RE: – SECTION 177AE - IDA Belview Infrastructure Development, Belview, Slieverue, County Kilkenny

Regarding the above-mentioned planning permission, please find our response to the clarification email dated Friday 19th June 2026.

Project: **IDA Belview Infrastructure Development**

Drawing No.:
12001–2020 Proposed Ducting Layout Sheet 2 of 2

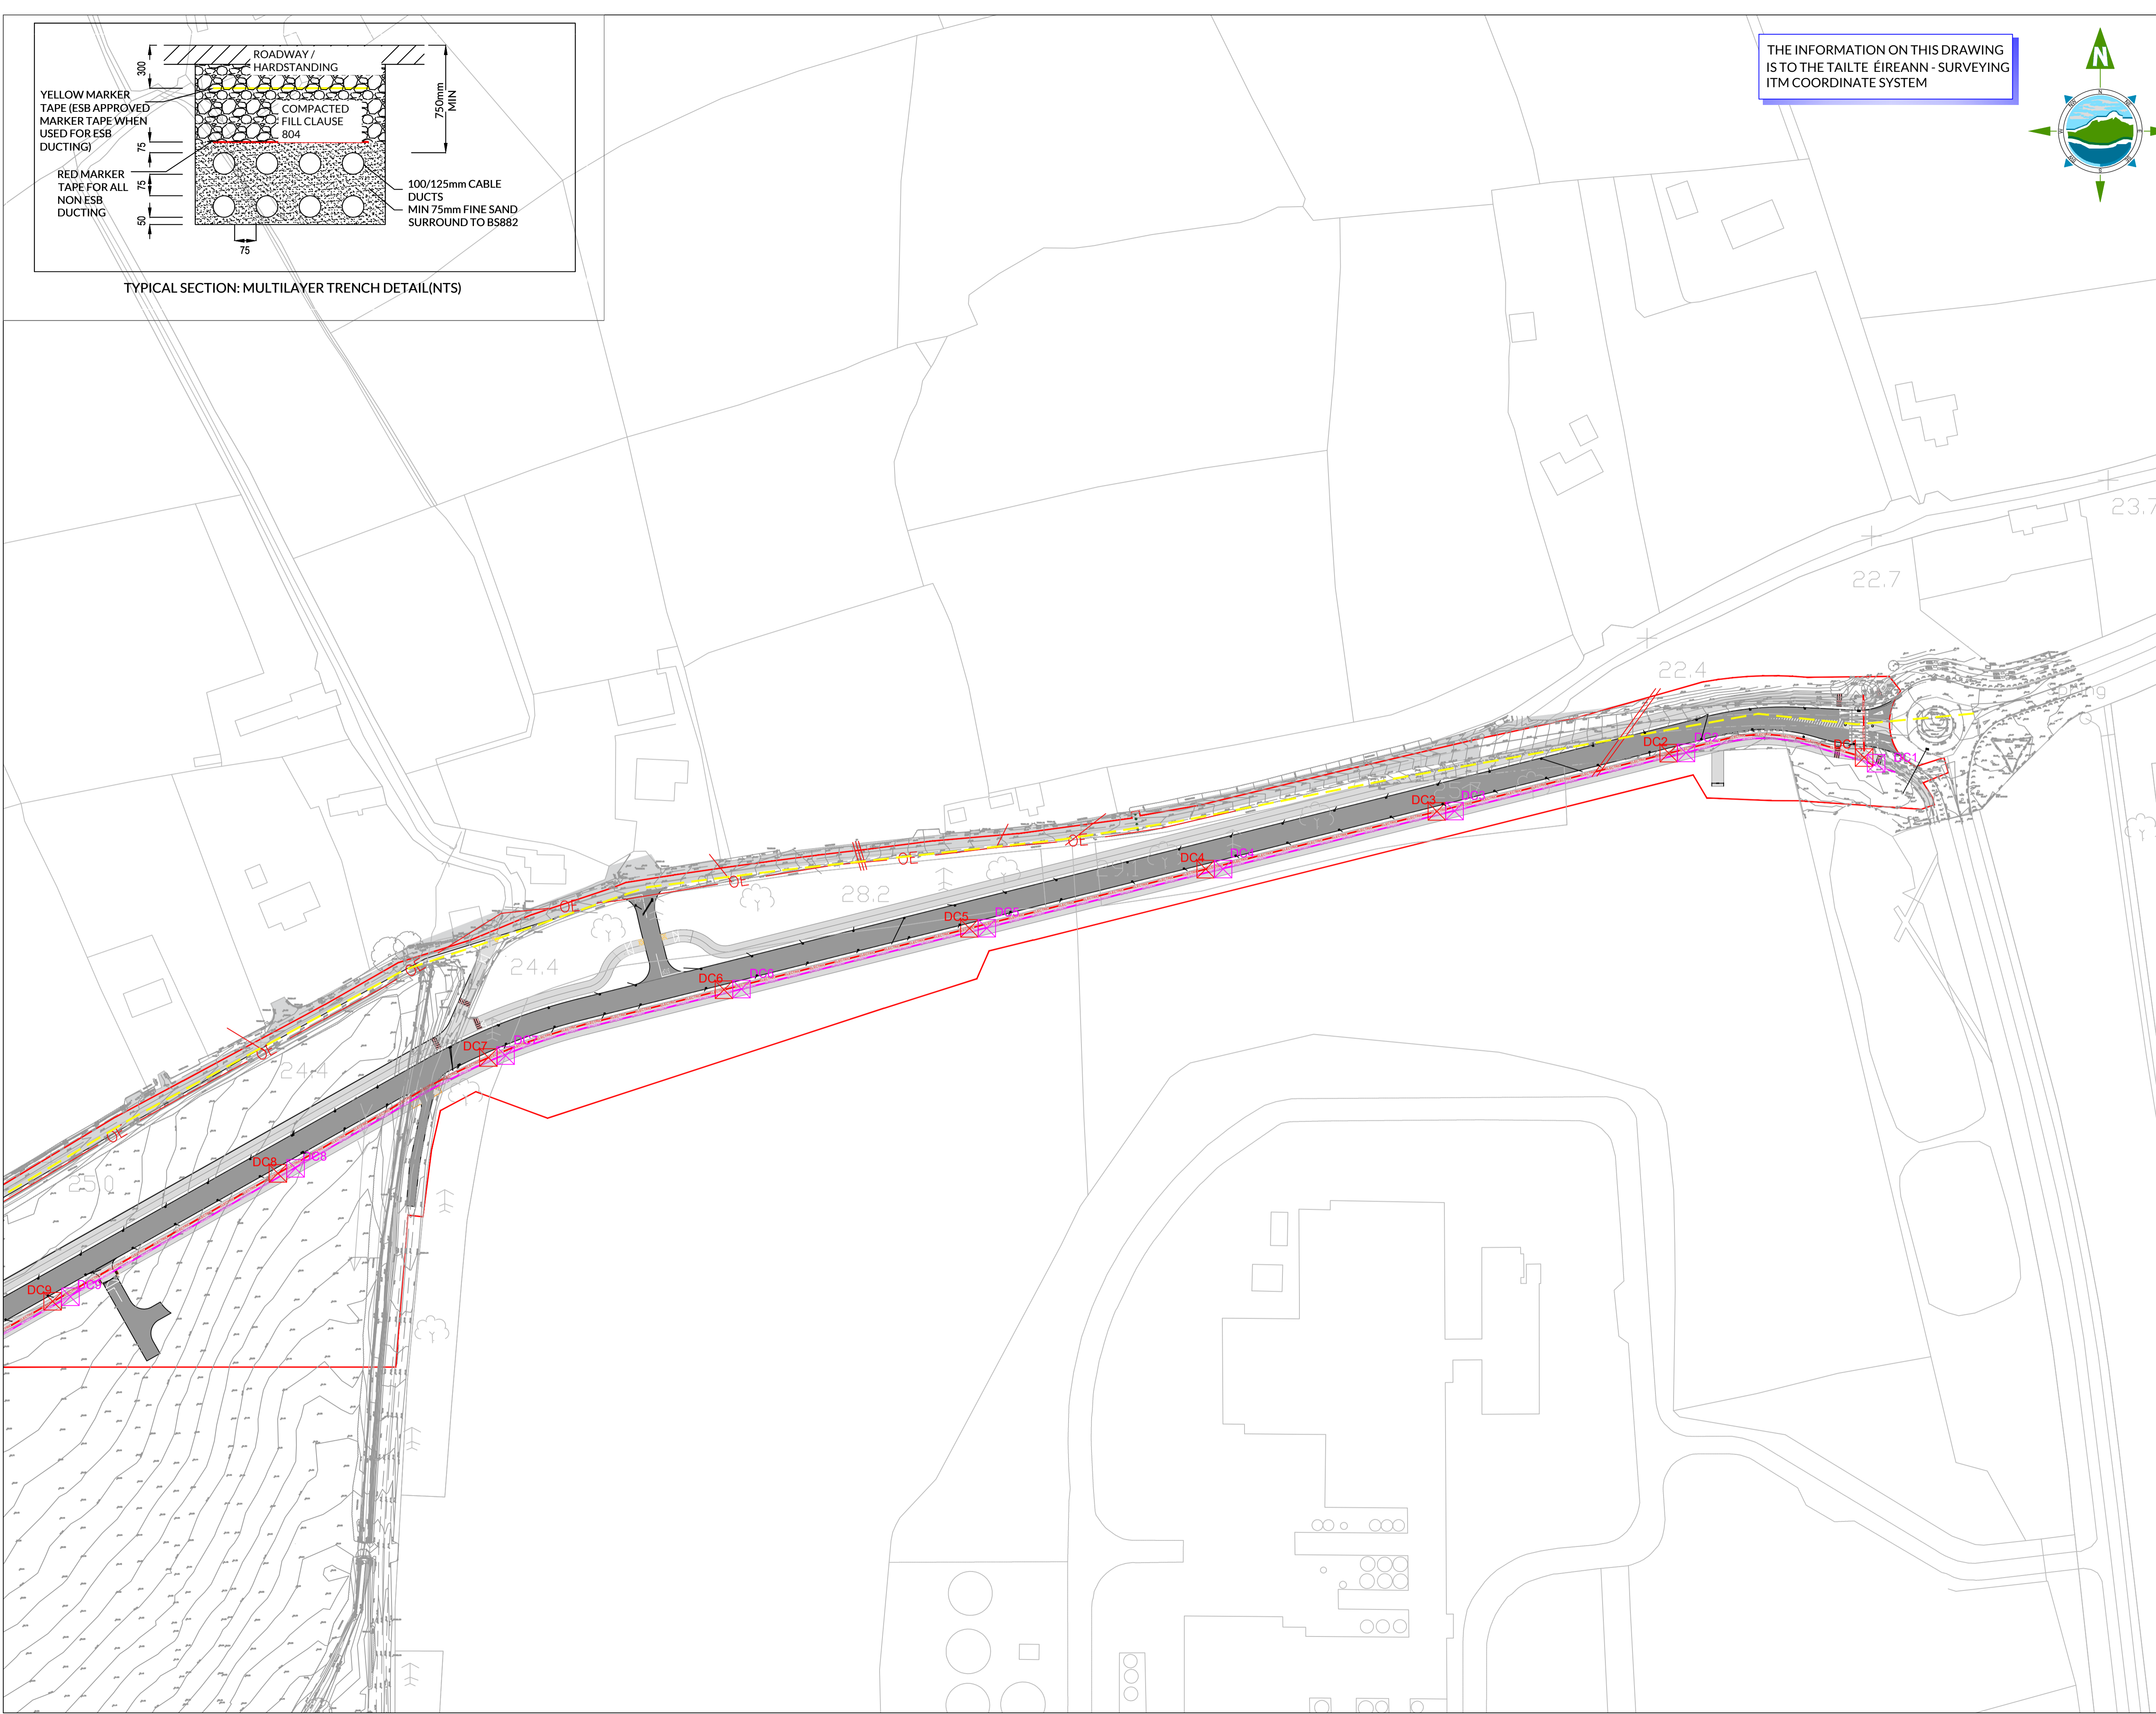
The drawing 12001-2020 is titled "Proposed Watermain Layout Sheet 2 of 2" on the hard & soft copy – in the document list is named "12001 - 2020 Proposed Ducting Layout Sheet 2 of 2".

The soft copy title for Drawing 12001 – 2020 has been revised from "12001-2020 Proposed Watermain Layout Sheet 2 of 2" to "12001-2020 Proposed Ducting Layout Sheet 2 of 2" to align with the document list (see Appendix A) and drawings in the civils drawing folder.
